CITY OF WESTFIELD, IN
Advisory Planning Commission Meeting Agenda - 4/21/2025
Monday, April 21, 2025 at 7:00 PM

2504-DDP-10

Element Hotel

Petition Number: 2504-DDP-10

Exterior Materials

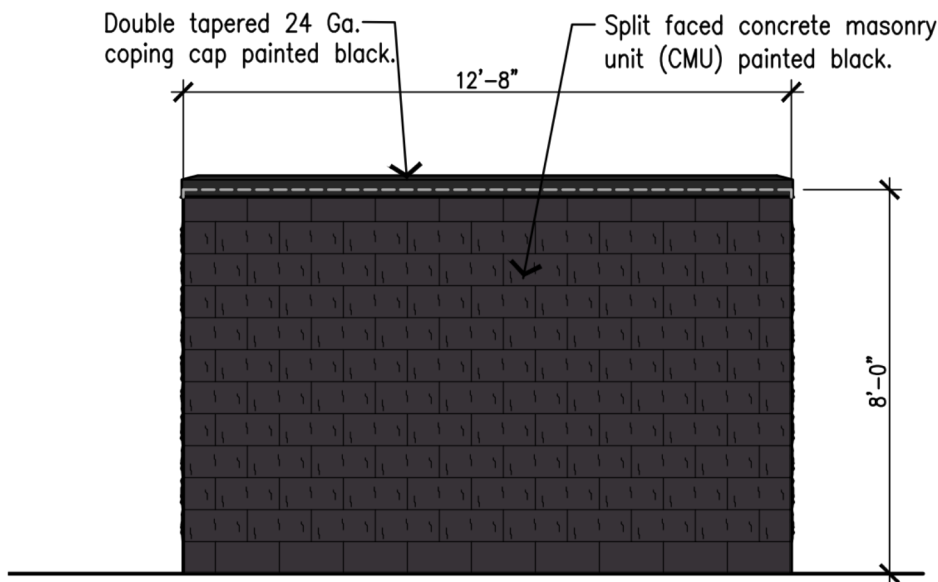
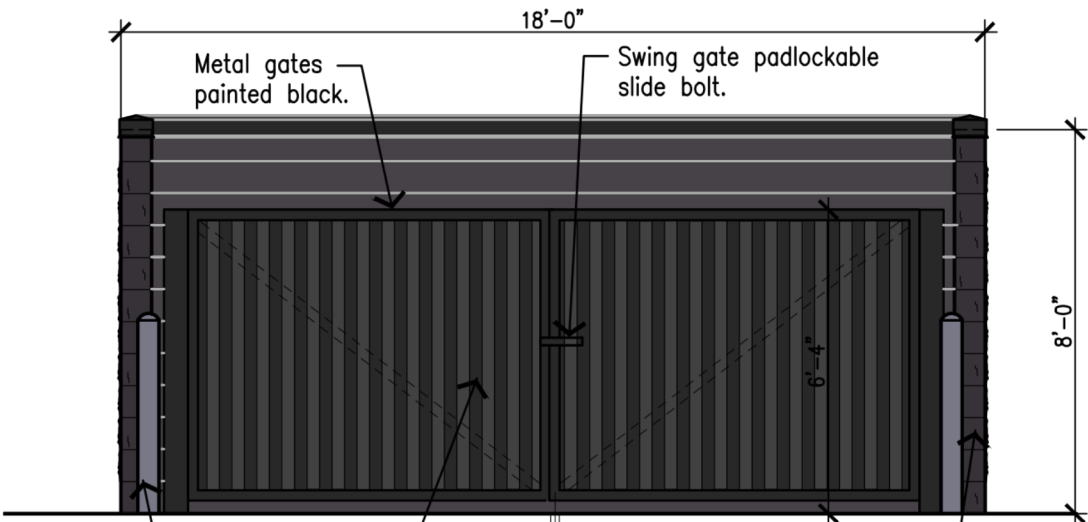
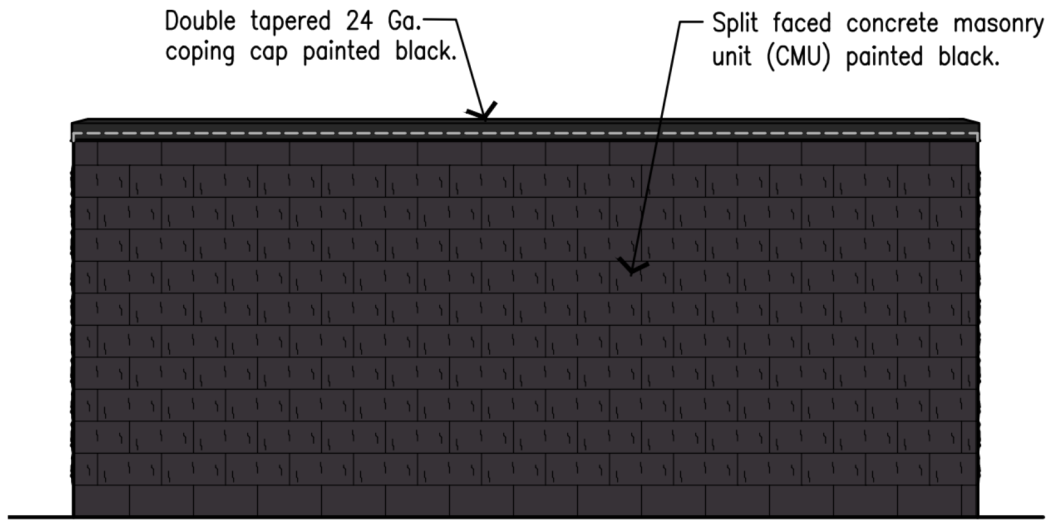
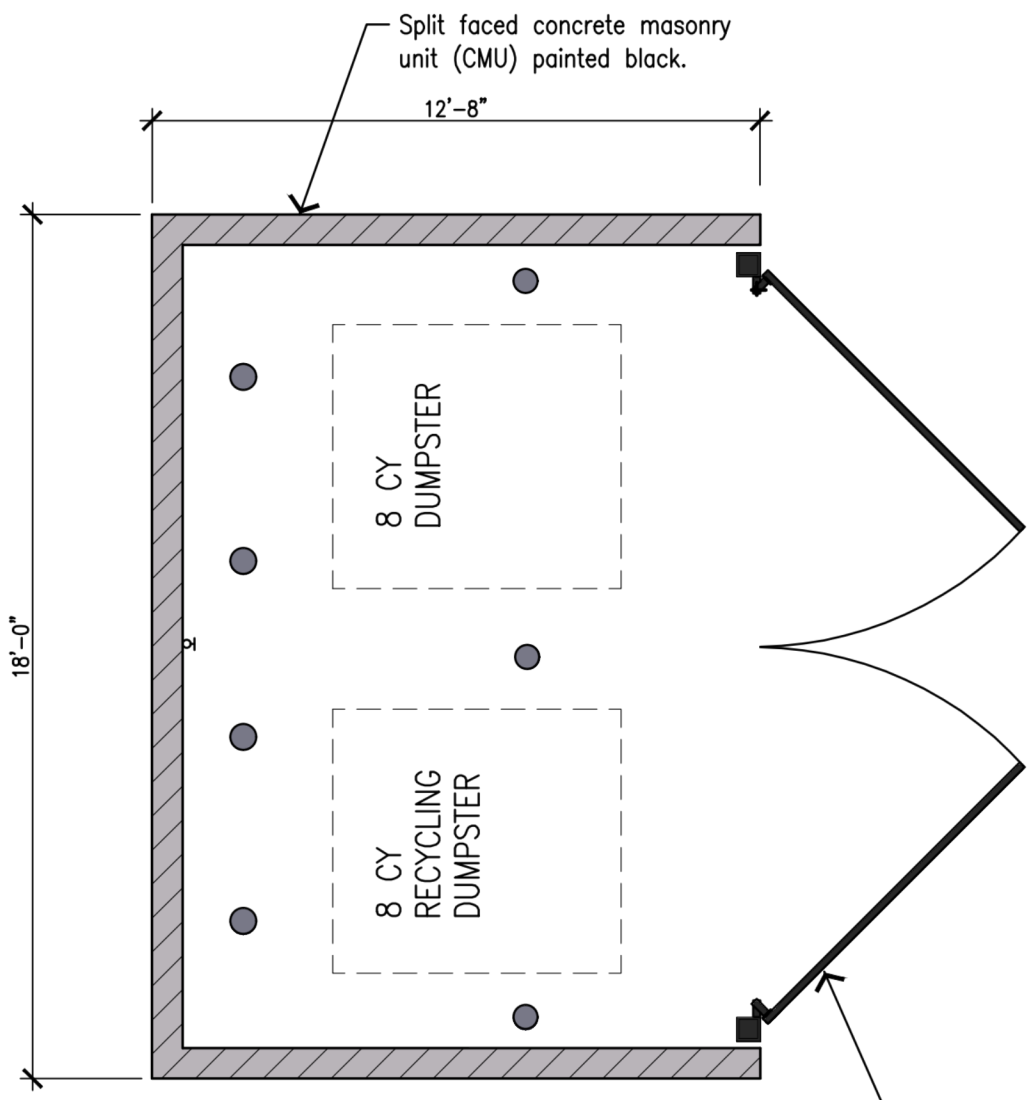
Comment: Ord. 25-15 set forth specific architectural standards. Plans comply.

Dumpster Enclosure
Plan and Elevations

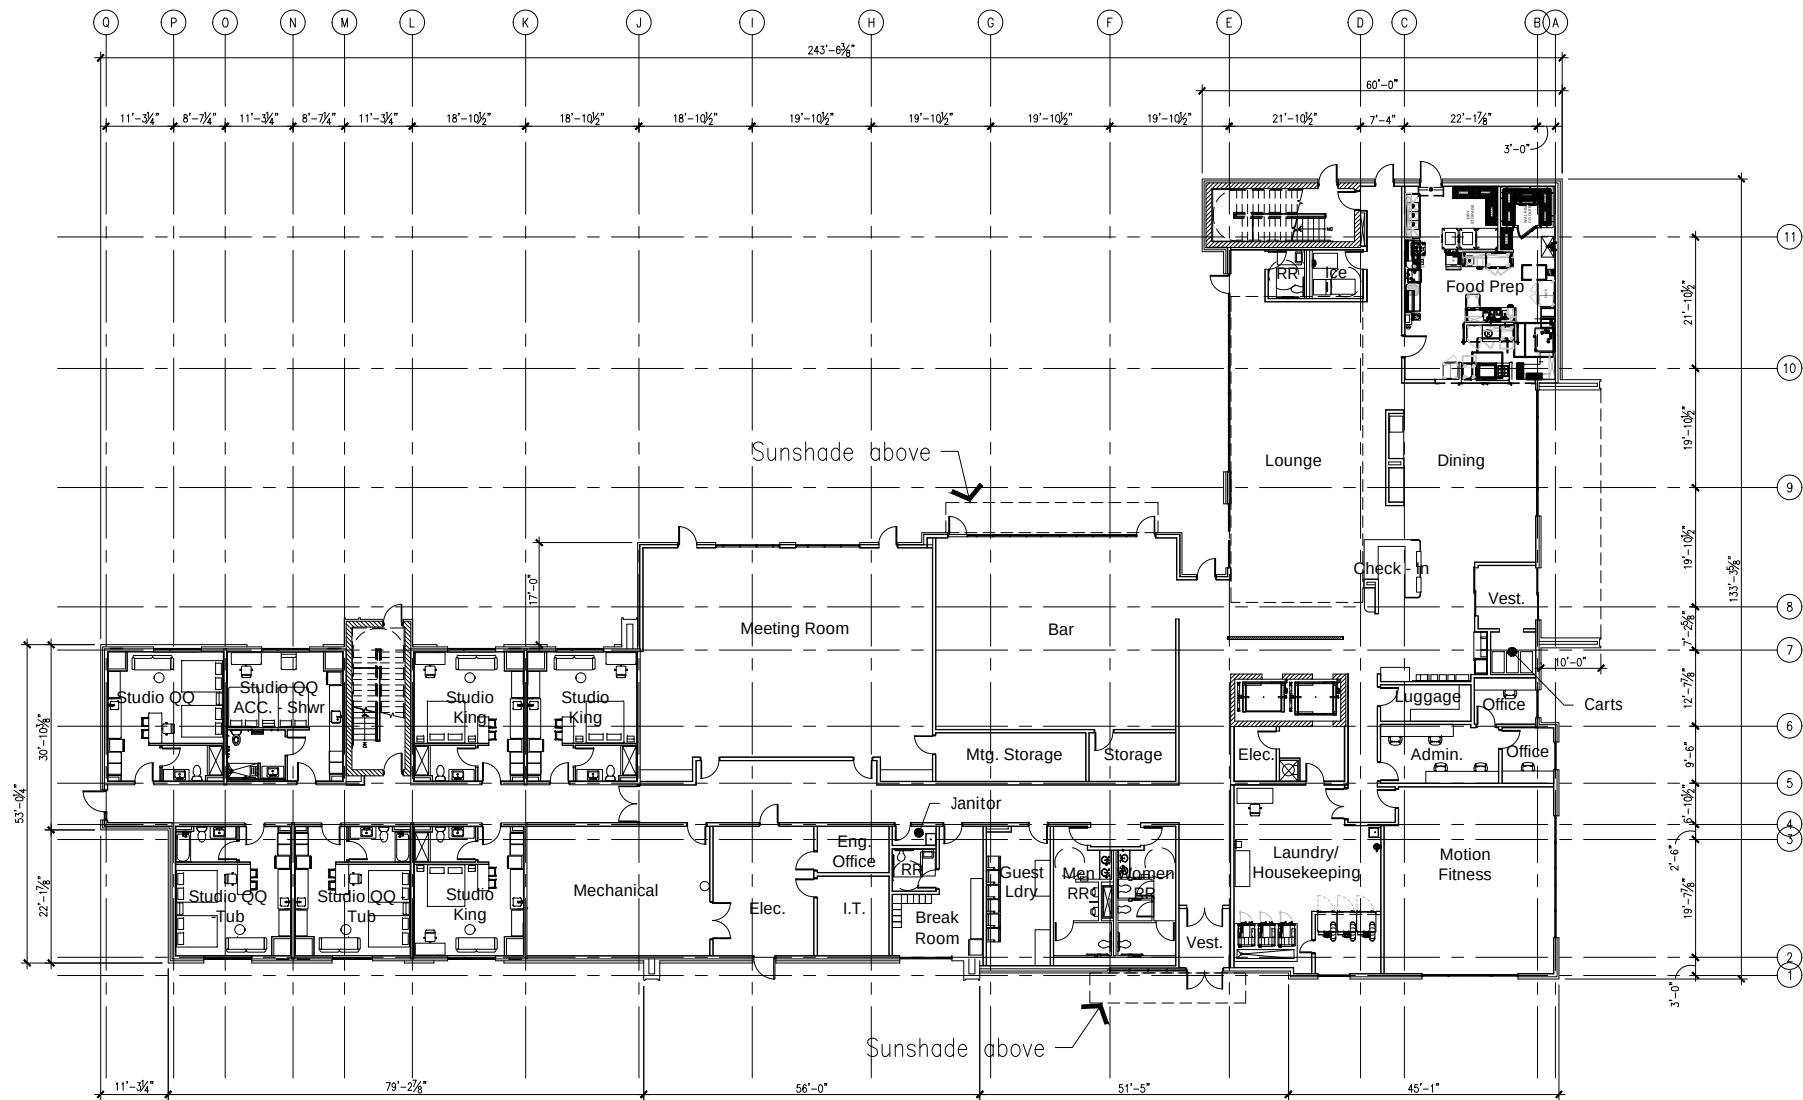
- b) Screening of Receptacles and Loading Areas:
 - i) Garbage containers, trash receptacles, pallet storage areas, trash compactors, recycling areas, loading areas and other similar facilities shall be completely and permanently screened from view of Rights-of-way and where possible, adjoining properties.

- ii) Screening methods shall include a solid enclosure on all sides not less than six (6) feet in height above grade or two (2) feet above the receptacle, whichever is greater. The solid enclosure shall be a Masonry Material that matches or complements the Principal Building.

- iii) Enclosures shall be constructed of a Masonry Material that matches or complements the Principal Building.
 - iv) Enclosures shall be equipped with opaque gates, as illustrated in FIGURE 6.1(2): DUMPSTER ENCLOSURES, that shall not be oriented towards residential properties or the Right-of-way, where possible.

- v) Enclosures shall have separate pedestrian access openings that are configured to conceal the dumpster from view for daily access to dumpsters for waste disposal. Pedestrian access openings shall be substantially similar to those illustrated in FIGURE 6.1(3): DUMPSTER MAN-DOORS.
